Product Change Notification

Date Issued :	October 25, 2022	PCN Number :	512647
Reason for Change :	Change to Product		
Description of Change :	The outer sleeve of the UltraLock head did not rotate freely. to ensure free rotation, the rear step of the inner sleeve was adjusted accordingly. The diameter was reduced and the step made longer.		
Reason for Short Notice :	Corrective Actions		
Assessment of Change :	First Article Inspection		
Planned Implementation Date :	November 25, 2022		
Sample Availability Date:	September 30, 2022		
Internal Molex Qualification Date :	September 30, 2022		
Last date to request Samples by Customer :	October 14, 2022		
Traceability Code Markings / Date :	No special marking on the product or packaging

Before Picture

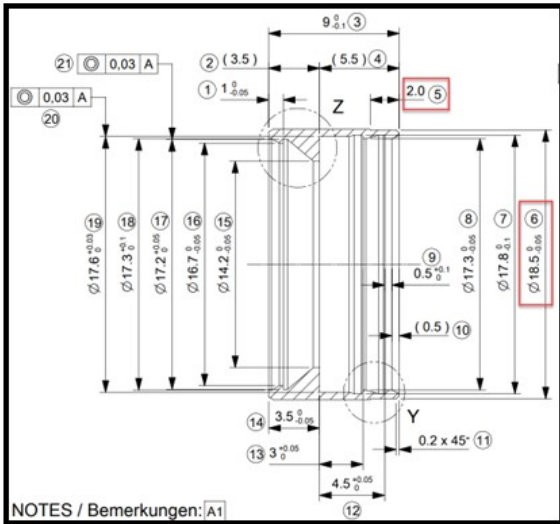
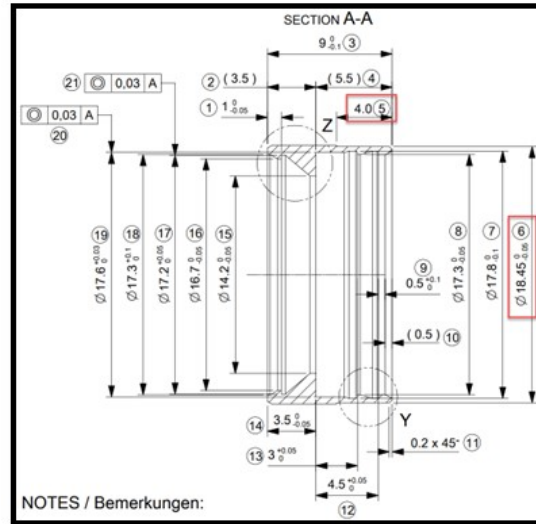
- The outer sleeve of the UltraLock head did not rotate freely. To ensure free rotation, the rear shoulder of the inner sleeve was adjusted accordingly. The diameter was reduced and the step made longer.

- Product Impact
 - No impact for function
